Subject: **Data Gap Work Plan and Focused Site Conceptual Model**
Port of Oakland, Former Carnation Terminal, Berth 30
Fuel Leak Case No. RO0000059
Alameda County, California
Amec Foster Wheeler Project No. 8416182190.1a

Subject: Data Gap Work Plan and Focused Site Conceptual Model
Port of Oakland, Former Carnation Terminal, Berth 30
Fuel Leak Case No. RO0000059
Alameda County, California

The following are the technical comments provided by ACDEH in its July 14, 2016 letter. These technical comments identify data gaps that need to be met to meet LTCP criteria for case closure.

Figure
3

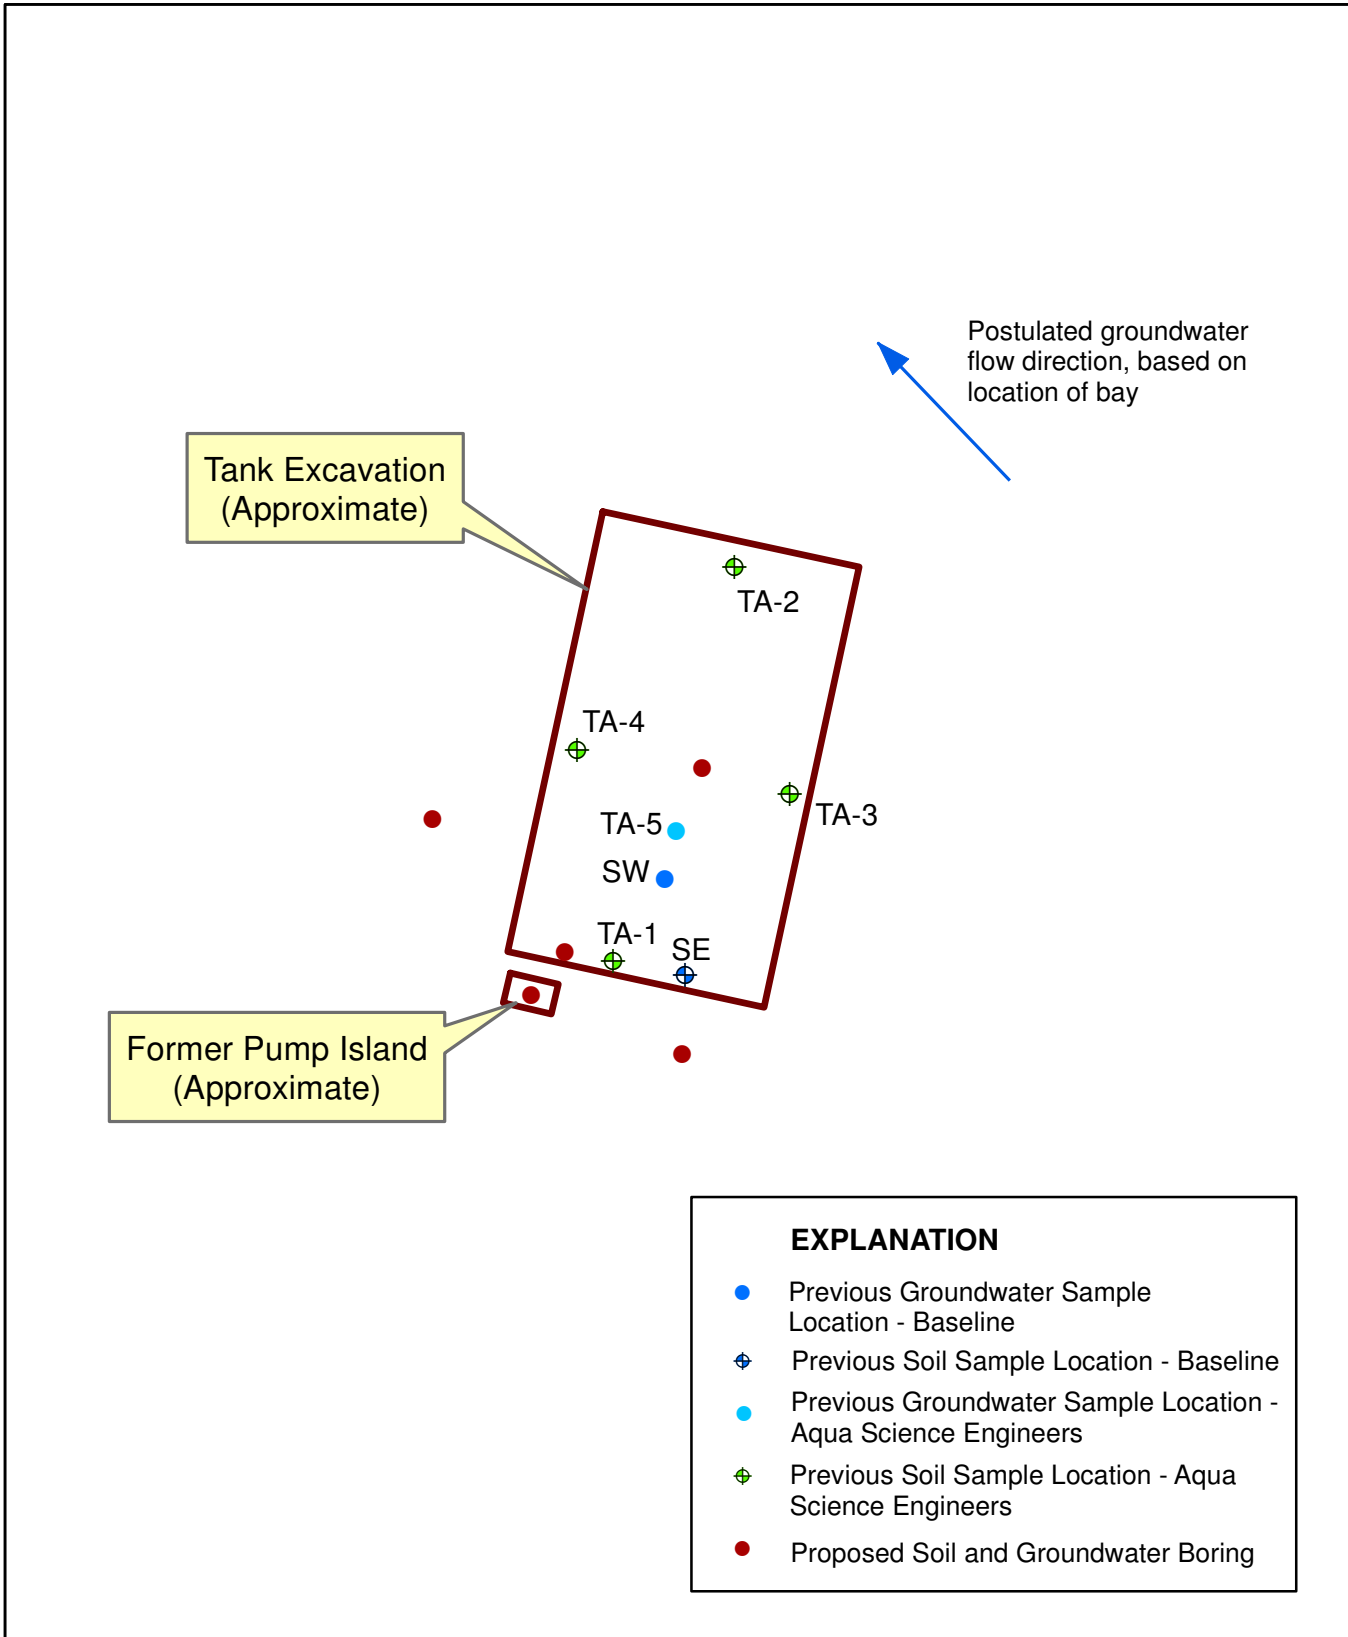
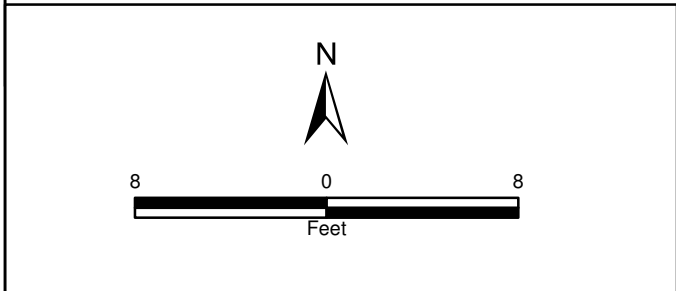
The sample location depicted for SE is northerly and farther inside the pit and collected at a shallower depth than the TA-1 location. Therefore, it is unclear what sample SE represents as the location described appears to be in an open area of the tank pit. Additionally, no samples were recovered beneath the nearby dispenser island depicted south of the tank pit. Hence, ACDEH can come to no conclusion with regard to secondary source removal in the southern tank pit and dispenser areas.

Our review of the case files indicates that insufficient data collection and analysis has been presented to satisfy the media-specific criteria for direct contact and outdoor air exposure. Specifically, no soil samples have been collected in the 0- to 5-foot bgs interval. Also, soil samples were not recovered from beneath the fuel dispenser island depicted south of tank pit sample TA-1, the area demonstrating the most elevated contamination.

Therefore, please present a strategy in the Data Gap Work Plan described in Technical Comment 7 below to collect sufficient data to satisfy the direct contact and outdoor air exposure criteria in the areas of likely dispenser location. Sample and analyze soil within the 0- to 5-foot and 5- to 10-foot intervals, at the groundwater interface, lithologic changes, and at areas of obvious impact. Also collect a groundwater sample from each boring and propose the requisite analysis including naphthalene and polycyclic aromatic hydrocarbons (PAH) analysis.

The following sections describe the field program that is proposed to meet the objectives listed above. The investigation program will focus on collection and analysis of soil and groundwater samples from soil borings at five locations in the vicinity of the former UST. Drilling locations are based on the approximate location of the former UST excavation, which is based on review of historical aerial photographs and Sanborn maps as discussed above. The locations were selected to further investigate the presence and extent of previously detected petroleum hydrocarbons (TPH_g, diesel range hydrocarbons, and BTEX) in soil at the southern end of the former UST location and the former fuel dispenser island and assess if groundwater has been impacted by TPH, MTBE, and/or BTEX.

Five soil borings will be drilled and temporary wells installed and sampled in the vicinity of the former UST. Three soil borings will be drilled at the southern end of the former UST excavation, one in the center of the former UST excavation, and one beneath the location of the former dispenser island. The borings will be advanced to approximately 4 feet below the water table using a direct push drill rig equipped with a sample corer lined with clear acetate sleeves. It is anticipated that groundwater will be encountered between approximately 8 to 10 feet bgs; therefore, it is planned that the borings will extend to depths of 12 to 14 feet bgs. One soil sample will be collected within the 0- to 5-foot depth interval of each boring based on visual evidence of contamination, petroleum odor, elevated photoionization detector readings, lithologic changes, or at approximately 2.5 feet bgs if no evidence of contamination or lithologic
